NL response to GRB-67-08 (ETRTO)

NL agrees with ETRTO on 4% subset

Representativeness of C1 data used by NL study

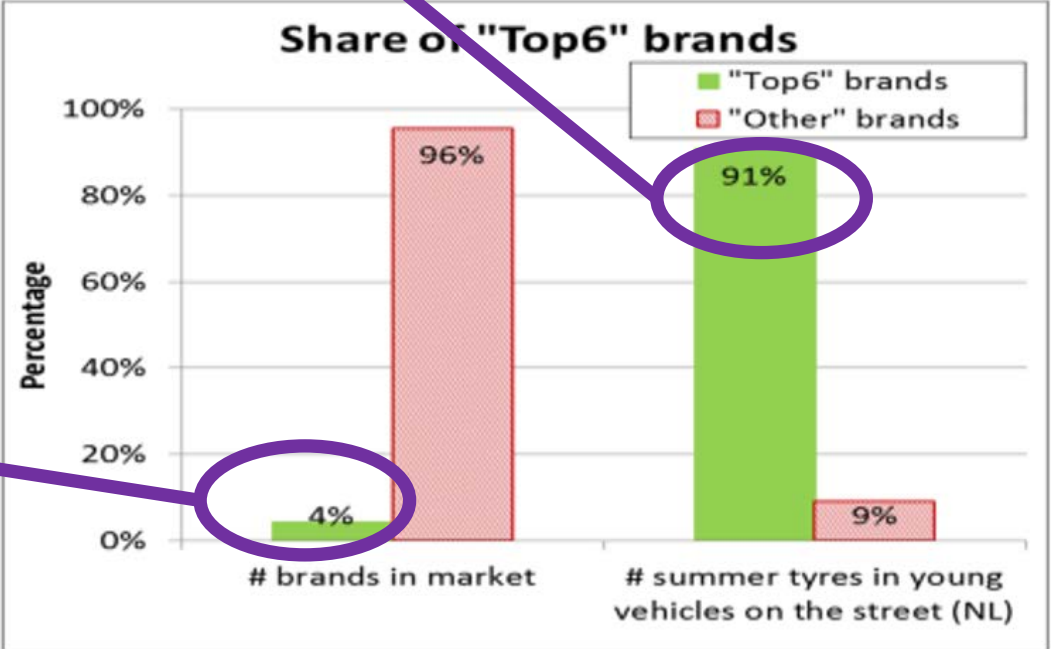
- But don't forget this 4% complies with >90% marketshare

96.2% of labels on the NL market in sizes and of brands which are not considered in the subset

Note: Representativity of a top 6
